DESCRIPTIVE REPORT

Registry No. H-10304

Sublocality Southwestern Chiginagak Bay

Descriptive Report to Accompany Hydrographic Survey H-10304

16568 6TH ED APR. 29/89 1:106,600 NAD 83 DATUM

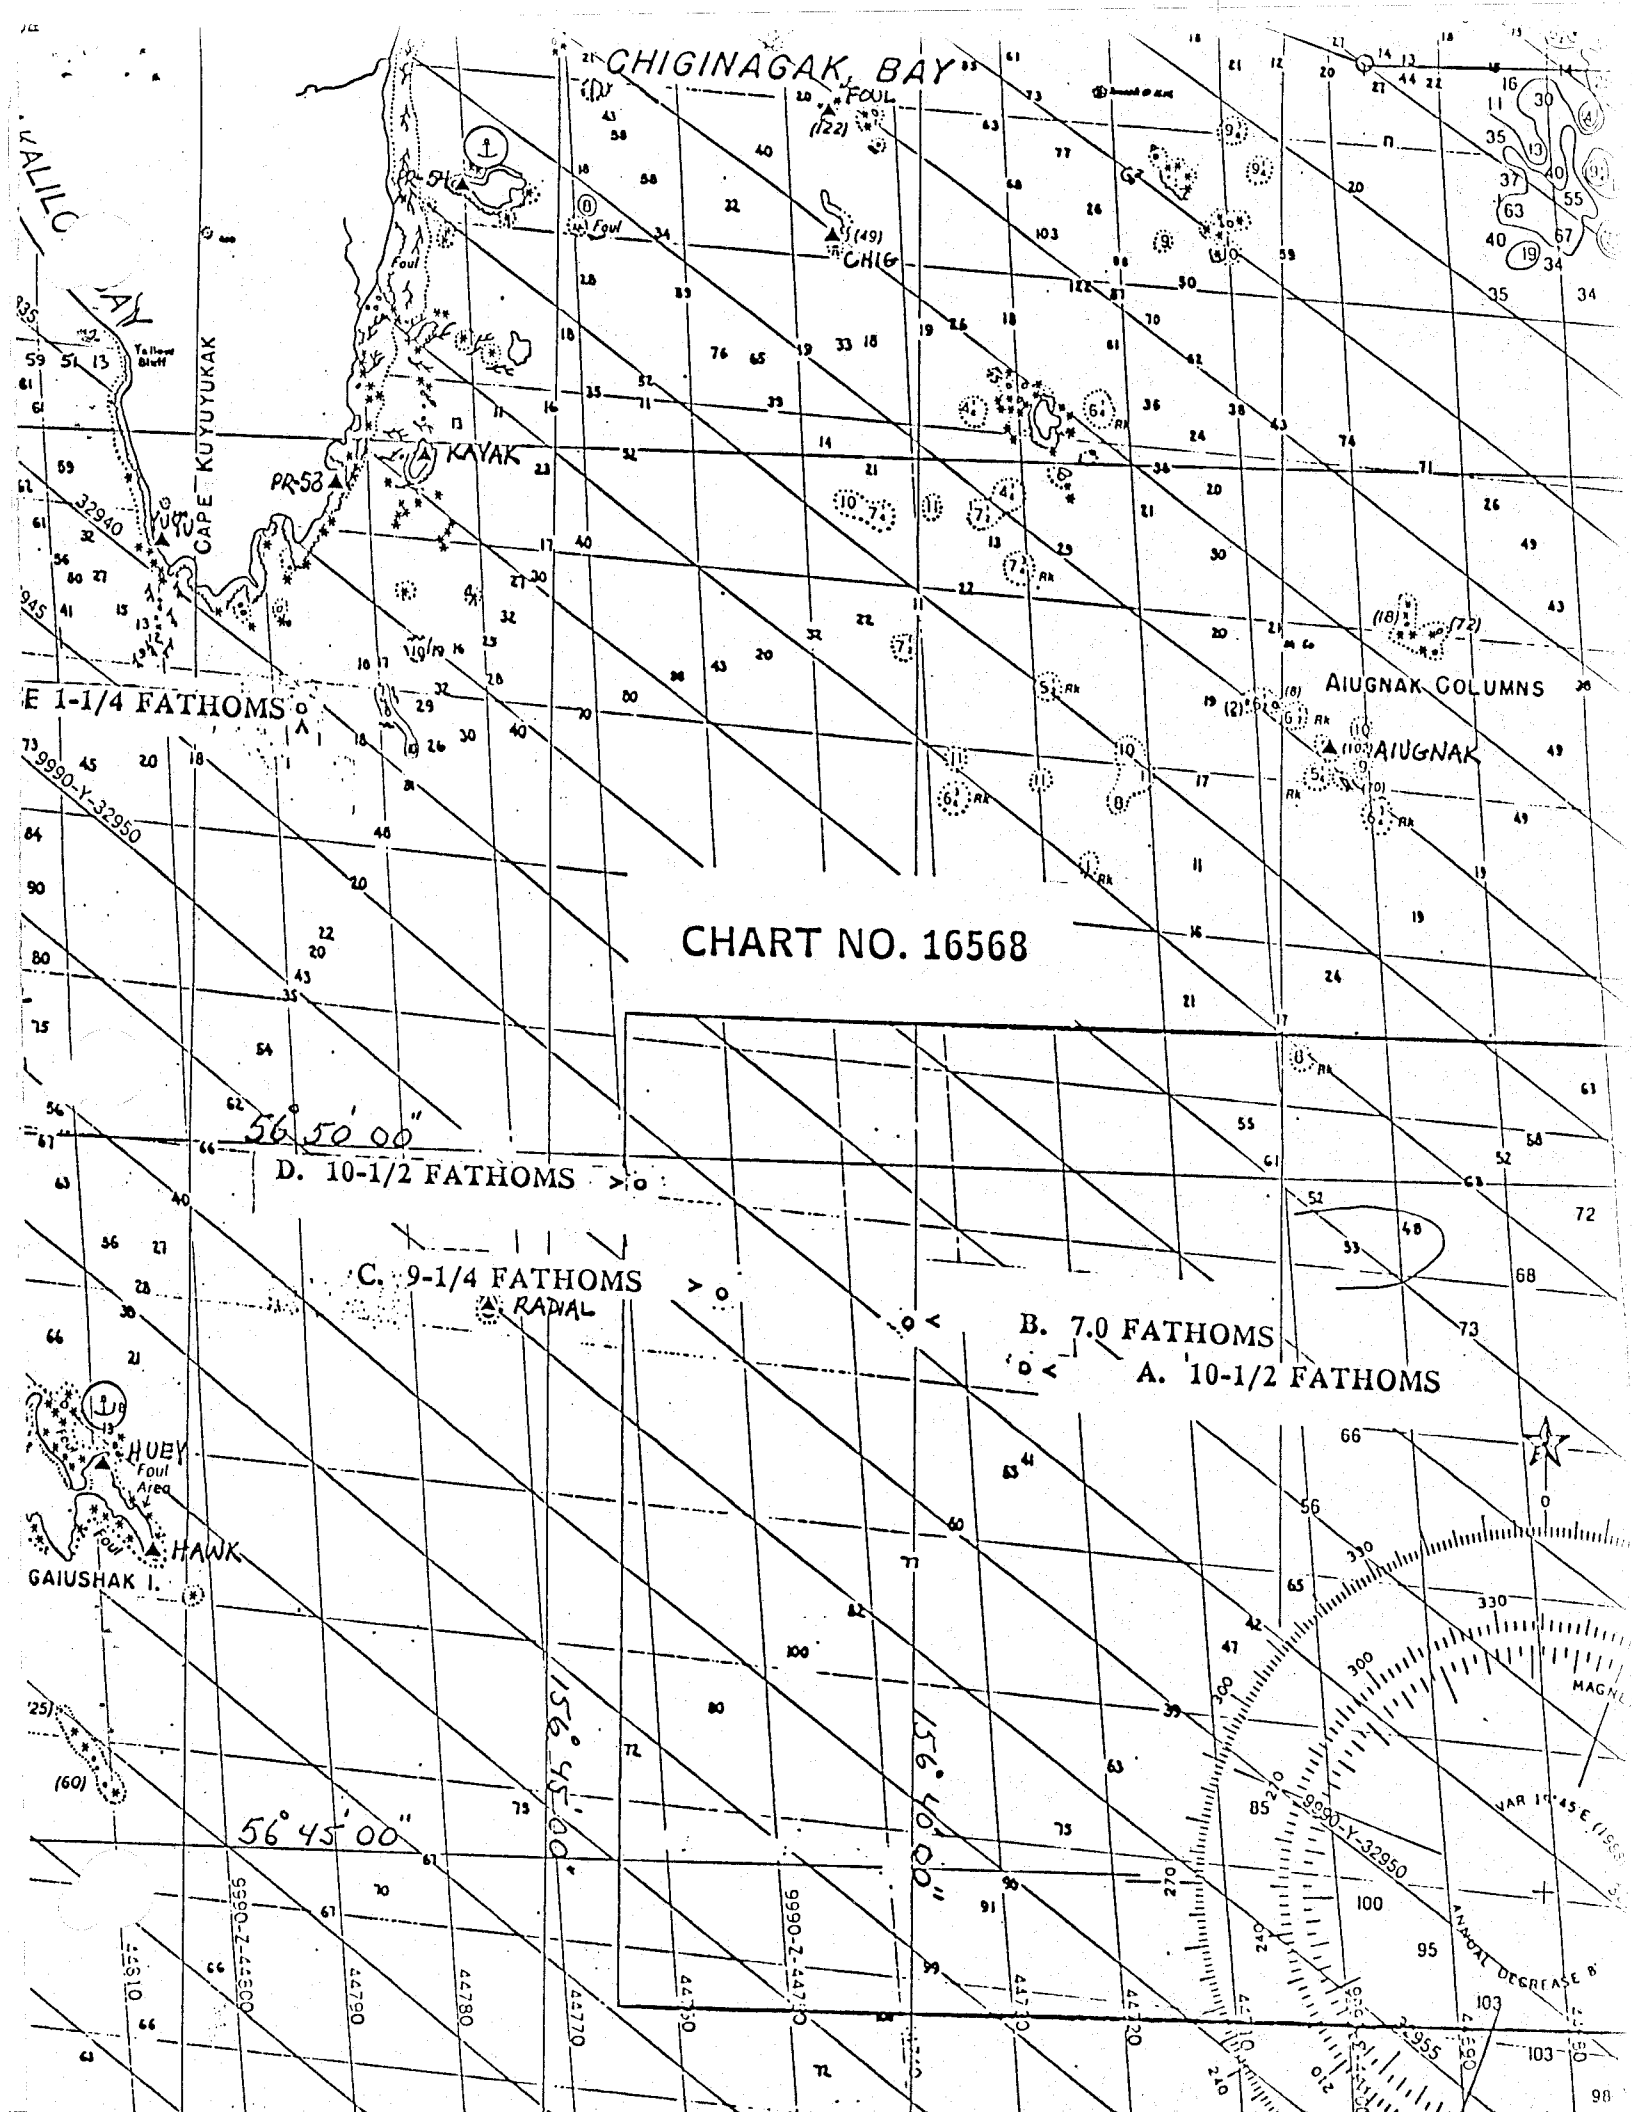
NOAA SHIP RAINIER HAS FOUND FIVE DANGERS TO NAVIGATION NEAR CHIGINAGAK BAY, ALASKA PENINSULA, ALASKA (PROJECT OPR-P180-RA) WITHIN THE LIMITS OF HYDROGRAPHIC SURVEYS H-10301 (SIX MILES SW OF AIUGNAK COLUMNS; ITEMS A-D) AND H-10304 (SOUTHWESTERN CHIGINAGAK BAY; ITEM E). REQUEST THE FOLLOWING BE PUBLISHED IN LOCAL NOTICE TO MARINERS FOR THE SEVENTEENTH COAST GUARD DISTRICT:

- A. "ROCK SUBMERGED 10-1/2 FATHOMS AT LATITUDE 56/48/35.8N, LONGITUDE 156/38/23.3W."
- B. "ROCK SUBMERGED 7.0 FATHOMS AT LATITUDE 56/48/53.9N, LONGITUDE 156/40/04.7W."
- C. "ROCK SUBMERGED 9-1/4 FATHOMS AT LATITUDE 56/49/01.5N, LONGITUDE 156/42/36.1W."
- D. "ROCK SUBMERGED 10-1/2 FATHOMS AT LATITUDE 56/49/46.7N, LONGITUDE 156/43/49.9W."
- E. "ROCK RIDGE SUBMERGED 1-1/4 FATHOMS AT LATITUDE *div site #9* 56/53/00.^{48"}~~48"~~^{23'}~~23'~~ *pos # 4286.* LONGITUDE 156/48/31.^{23'}~~23'~~ *1.2 Fathom*"

Preliminary Chart 16568
6th Ed., Apr 29/89
1:106,600 NAD83

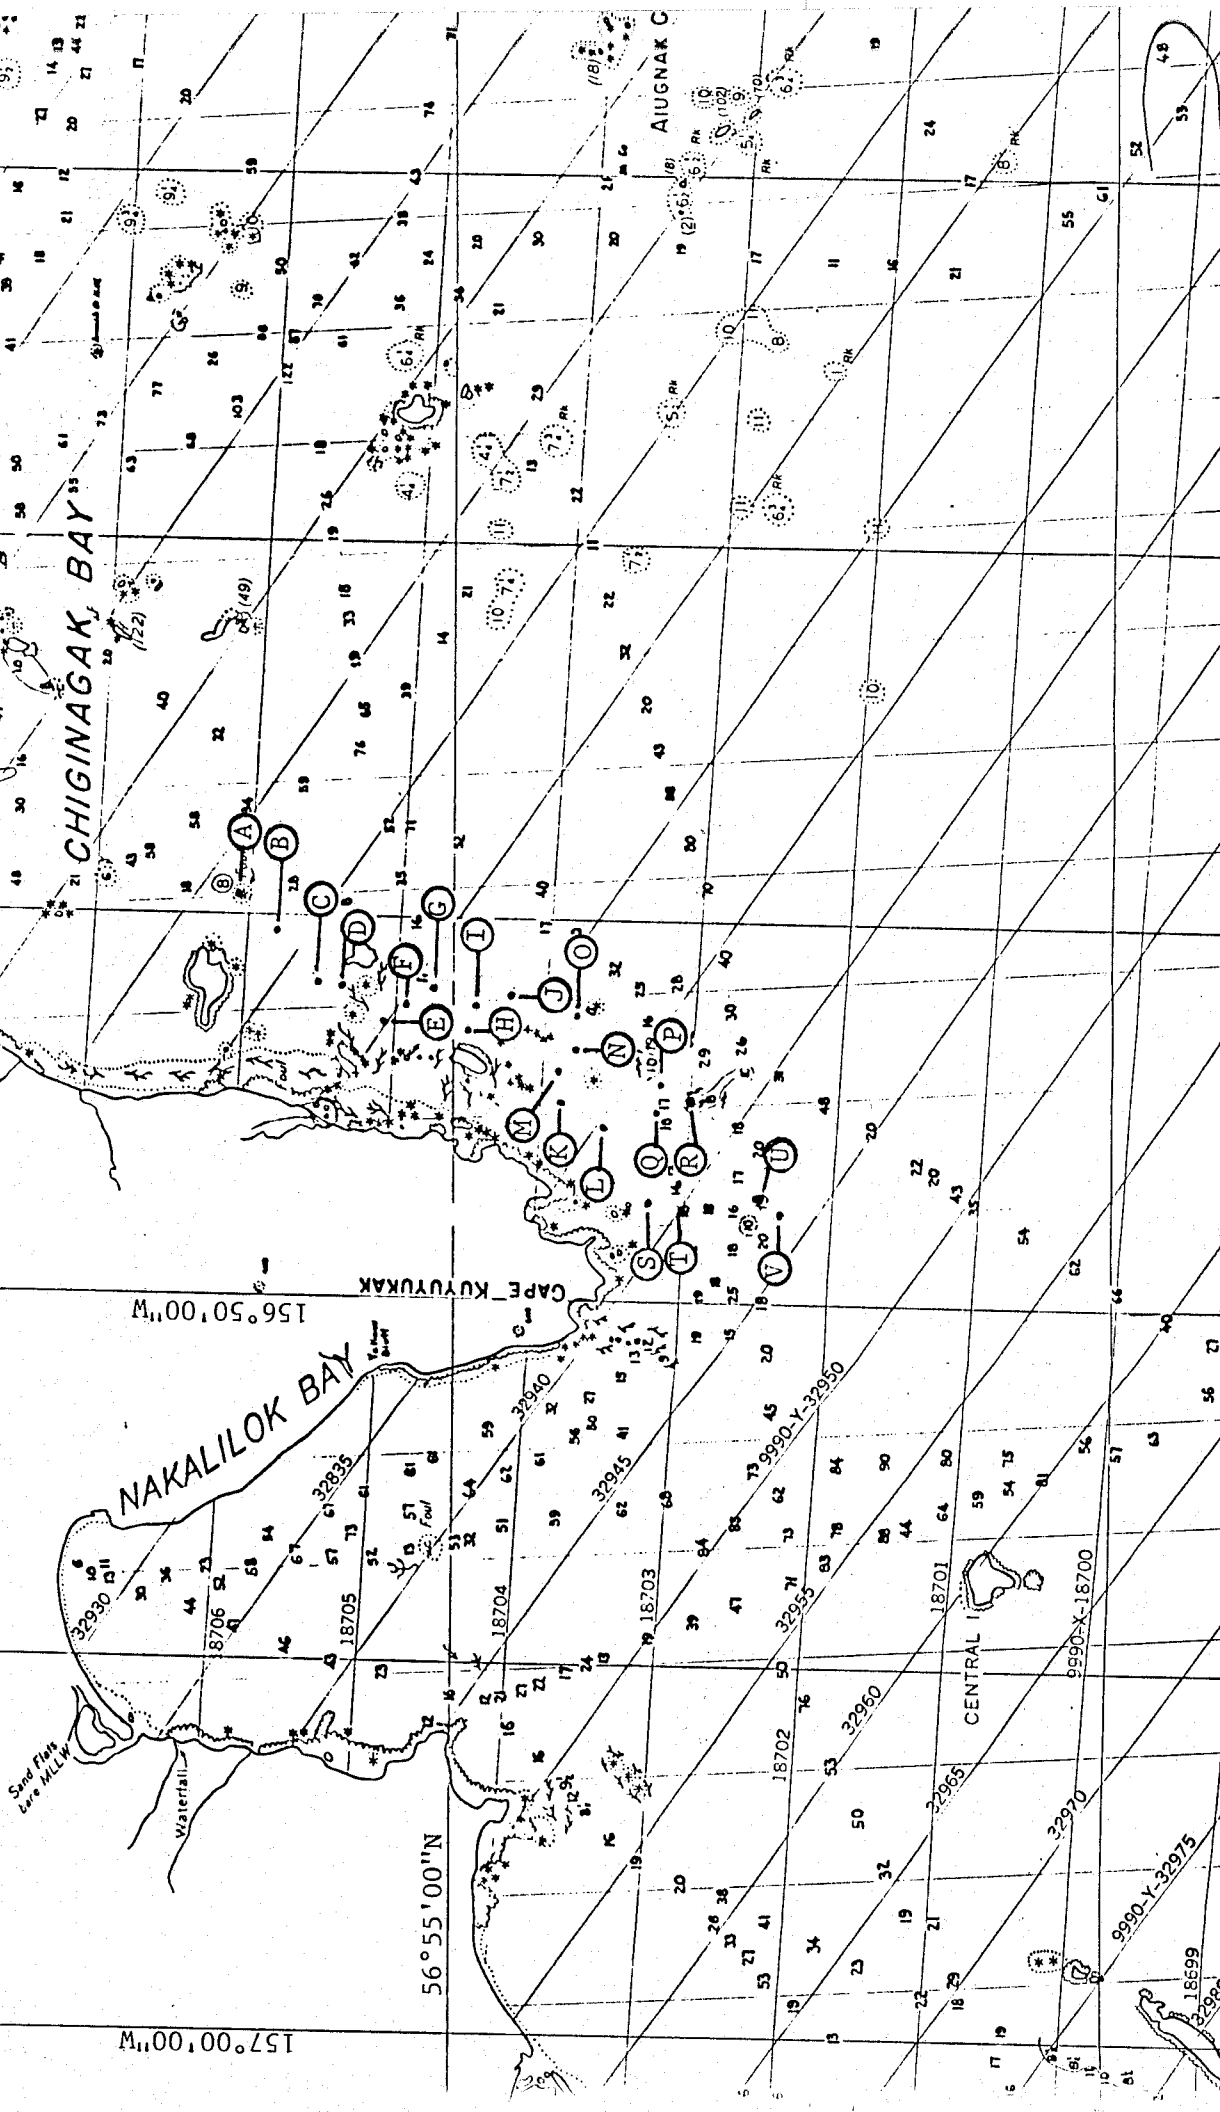
H. ROCK PINNACLE SUBMERGED 1 FATHOM AT LATITUDE 56/54/58.5N, LONGITUDE 156/46/28.5W. <i>1.2 FATHOMS</i> 56.15" 18.90"	55	5897
I. ROCK SHOAL SUBMERGED 6-1/2 FATHOMS AT LATITUDE 56/54/50.3W, LONGITUDE 156/46/06.3W. 52.94" 45/ 58.91"	57	3262

J. ROCK PINNACLE SUBMERGED 6-3/4 FATHOMS AT LATITUDE 6.8 FATHOMS
